SECTION: 417

Service Action: Left-Hand Rear Lamp LED Failure

XF (X250)

**VIN: R00001 - R61290
Model Year: 2009 - 2010**

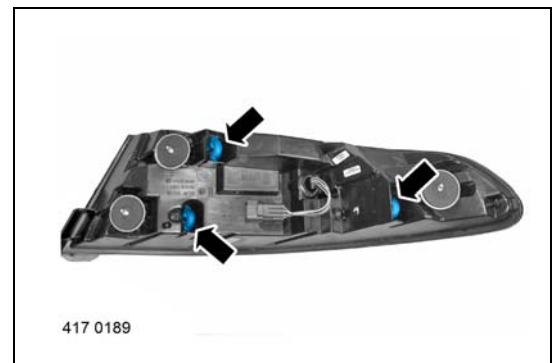
INSPECT LEFT-HAND REAR LAMP ASSEMBLY OPERATION

1. Turn the exterior lights 'ON'.
 - If the left-hand (LH) lamp assembly LEDs are functioning correctly, perform steps 2-4 below only.
 - If the LH rear lamp assembly LEDs are not functioning correctly, perform step 5 below only.
2. Refer to Workshop Manual, section 417-01: *Exterior Lighting*, and remove the LH rear lamp assembly.
3. Replace the vent tubes:
 - Release and remove the three (3) vent tubes from the lamp assembly.
 - Install three (3) new vent tubes to the lamp assembly.
4. Refer to Workshop Manual, section 417-01: *Exterior Lighting*, and install the LH rear lamp assembly.

- △ **NOTE: New lamps do not require vent tube installation.**
5. Refer to Workshop Manual, section 417-01: *Exterior Lighting*, and replace the LH rear lamp assembly.
